Village of Indiantown Development Review Colleagues **Staff Report**

Silver Fox Grid Station Rezoning

<u>Application Number</u>	RZ-26-001 (Rezoning)
<u>Project Name:</u>	Silver Fox Grid Station PUD
<u>Date of Report</u>	2-17-2026
<u>Property Owner</u>	Silver Fox 606, LLC.
<u>Applicant</u>	Silver Fox 606, LLC.
<u>Agent for Applicant</u>	Morris Crady, AICP Senior Partner Lucido & Associates, FL 33410
<u>Village Project Coordinator</u>	Deanna Freeman, Community and Economic Development Director

VILLAGE OF INDIANTOWN DEVELOPMENT REVIEW COMMENTS

SKETCH & LEGAL FOR: Silver Fox 606 LLC		
MARTIN COUNTY		FLORIDA
Scale: 1"=600'	Date: 2026	File & Drawing No.: 24-1039-02
Drawn By: M.F.M.	Checked: P.A.	Sheet 3 OF 3

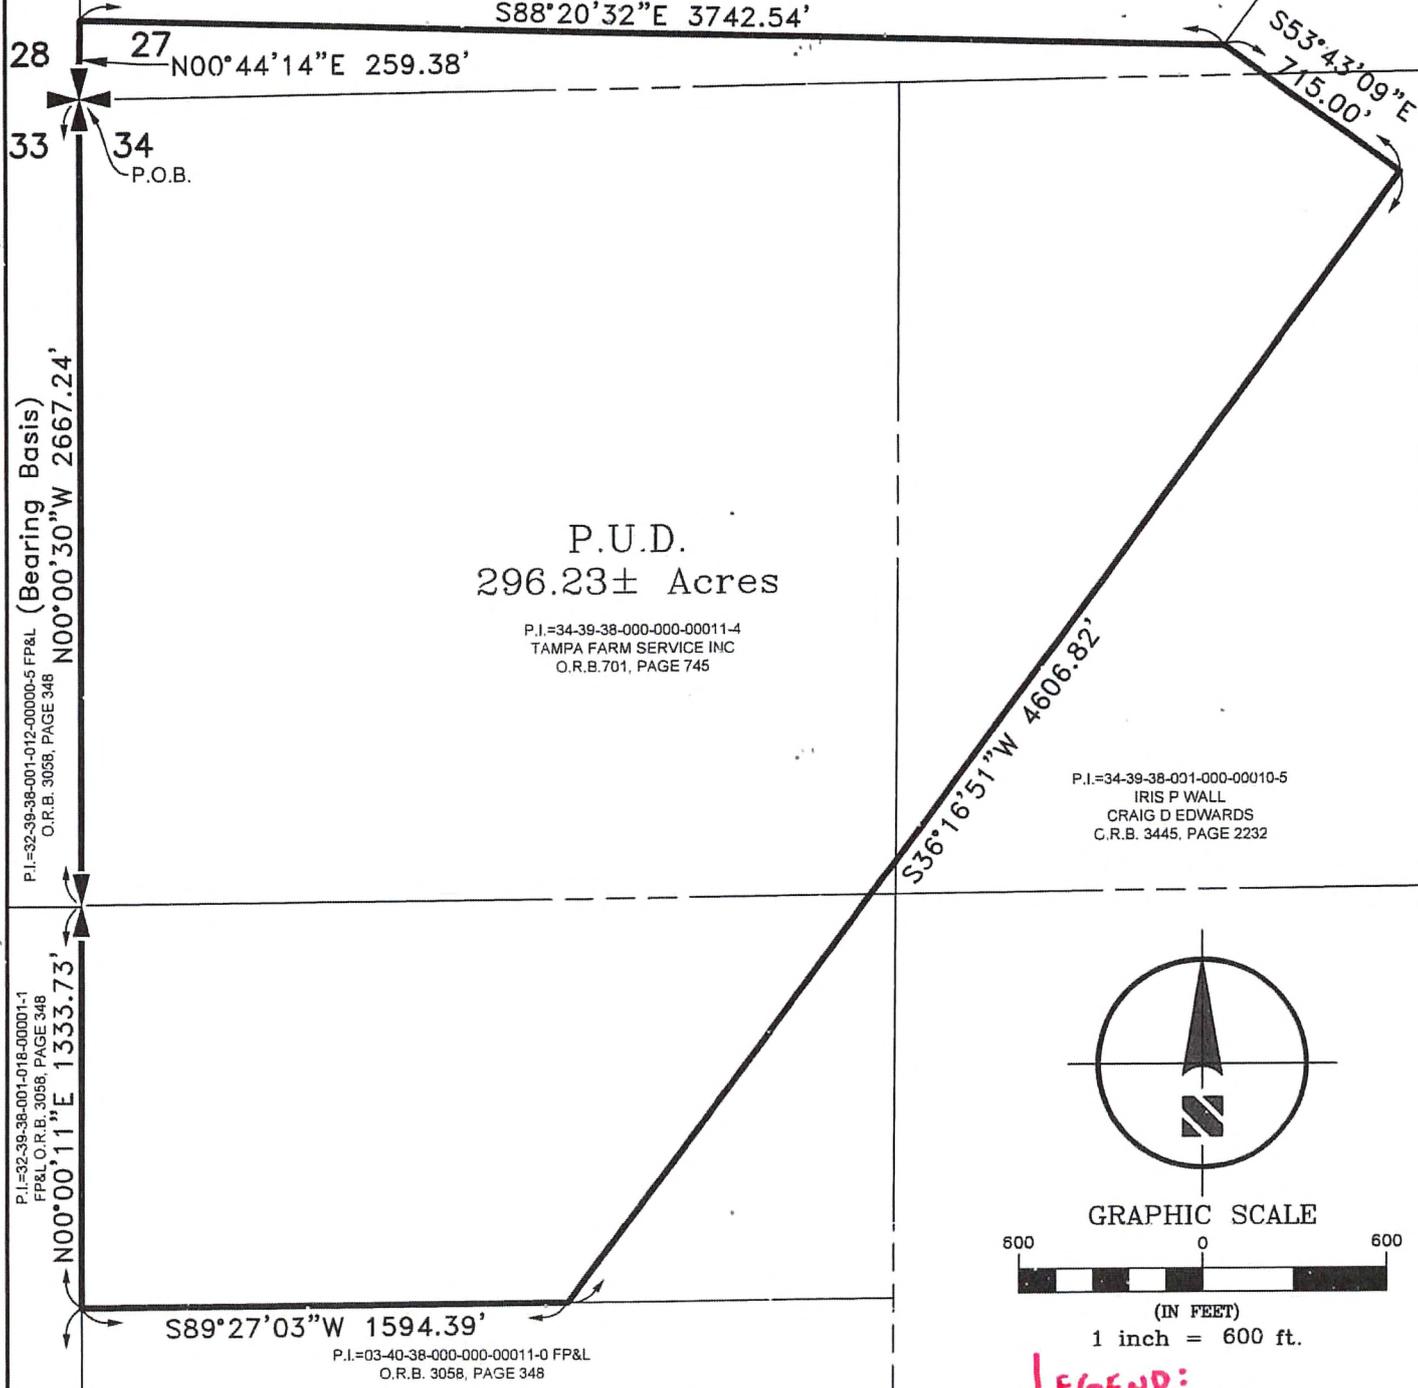
MISSING DISTANCE

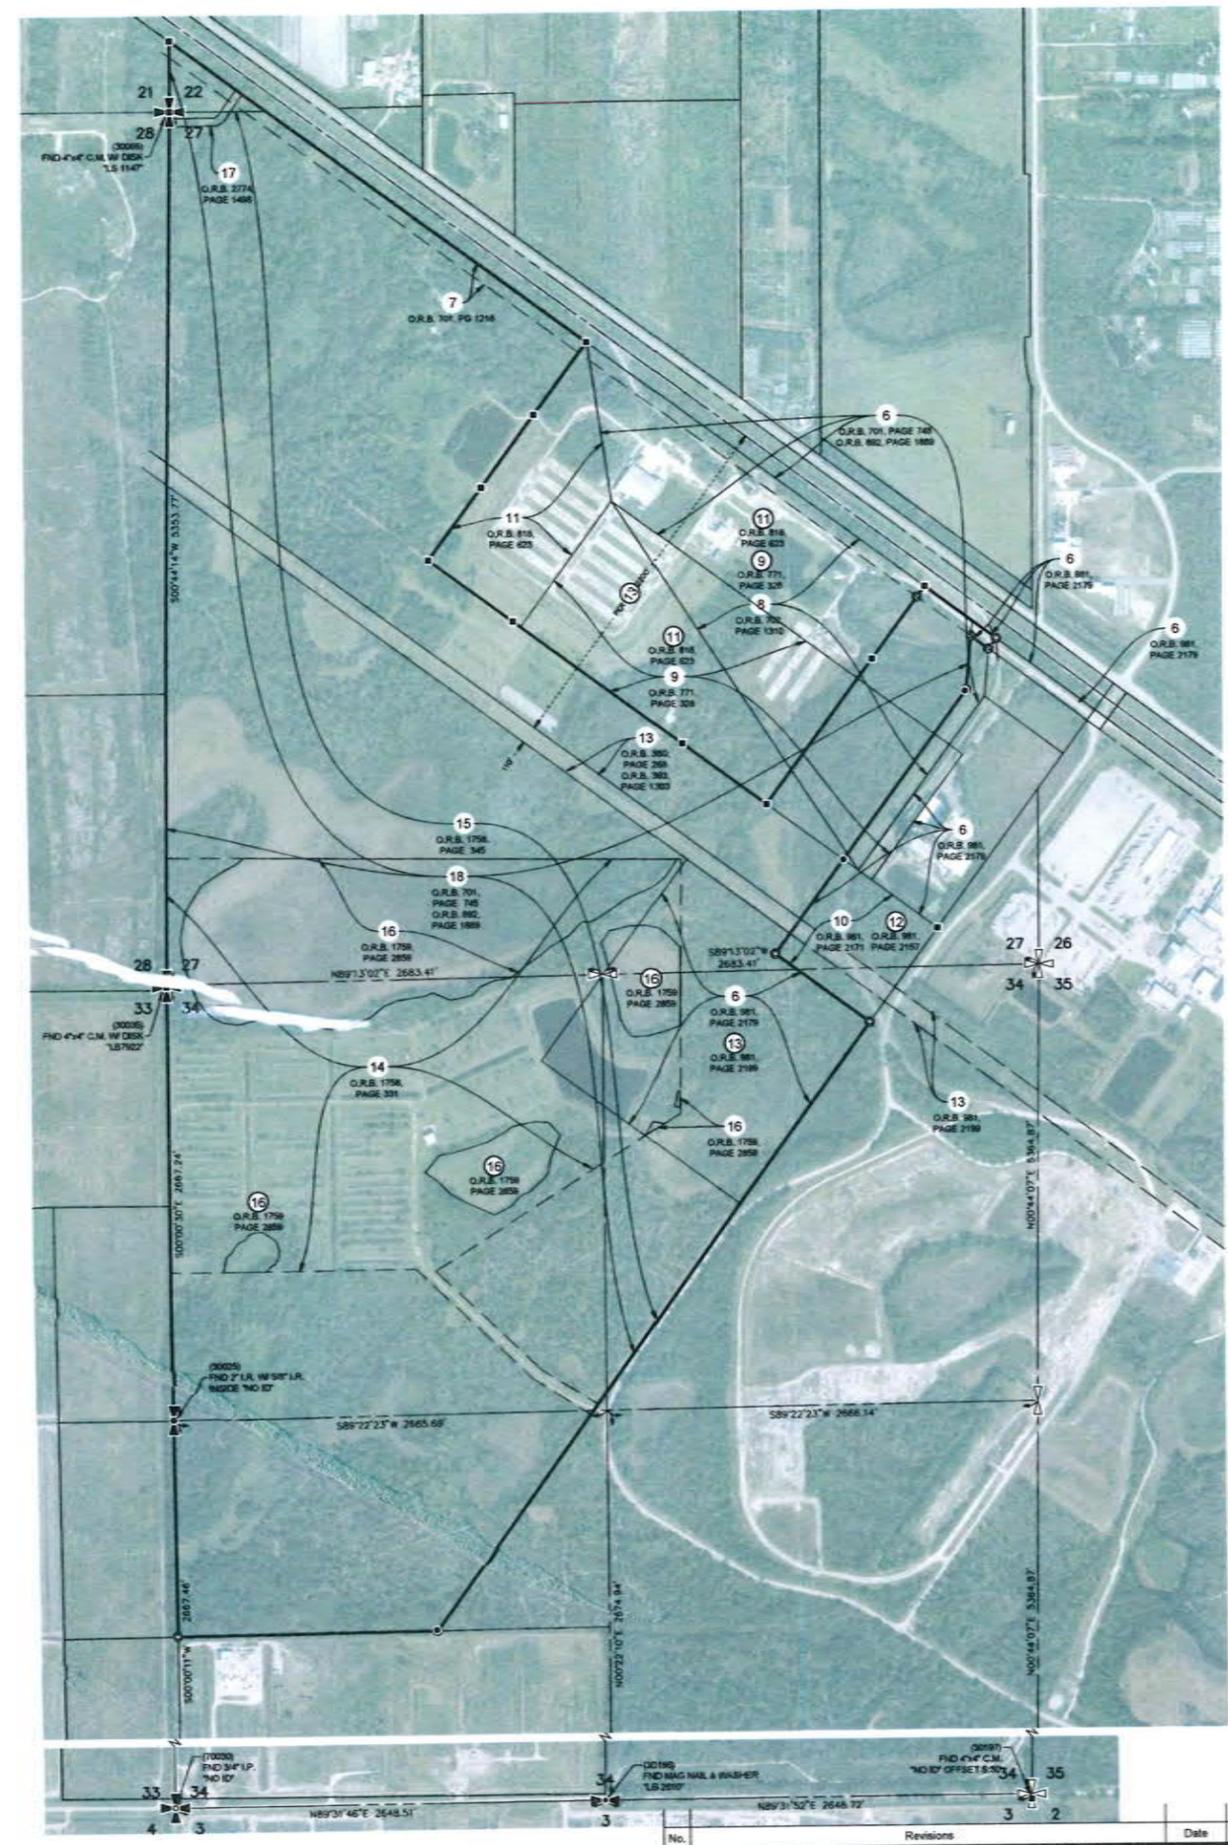
CONSIDER THE USE OF HATCHING TO CLEAN UP, THIS IS HARD TO FOLLOW

Scale: AS SHOWN	Date: Feb. 2025	File & Drawing No: 24-1039-01-02
Drawn By: M.F.M.	Checked By: P.A.	Sheet: 6 of 6

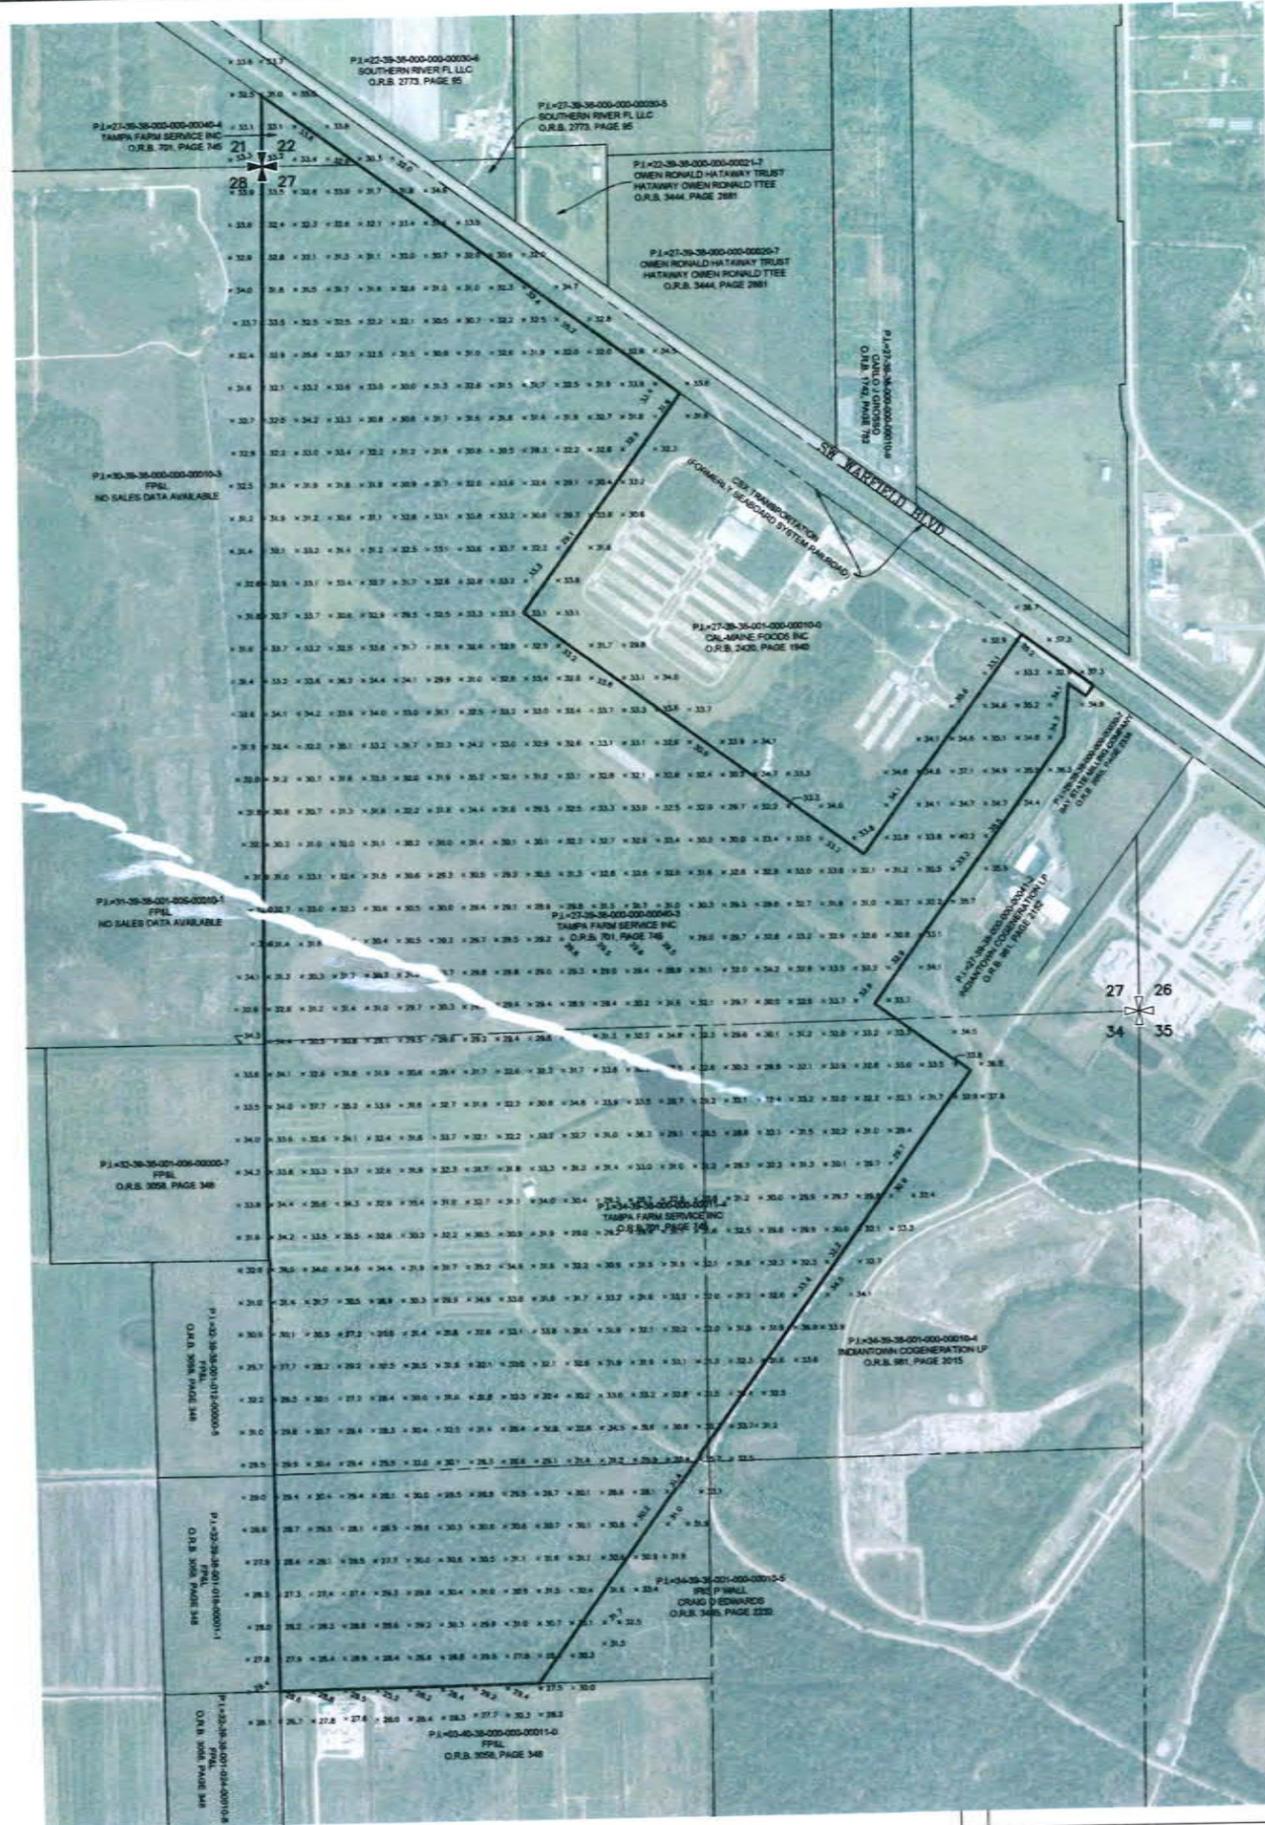
REVIEW GRID AND CONSIDER
NOT SHOWING ELEVATIONS IN
WATER BODIES THAT HAVE NOT
BEEN SURVEYED
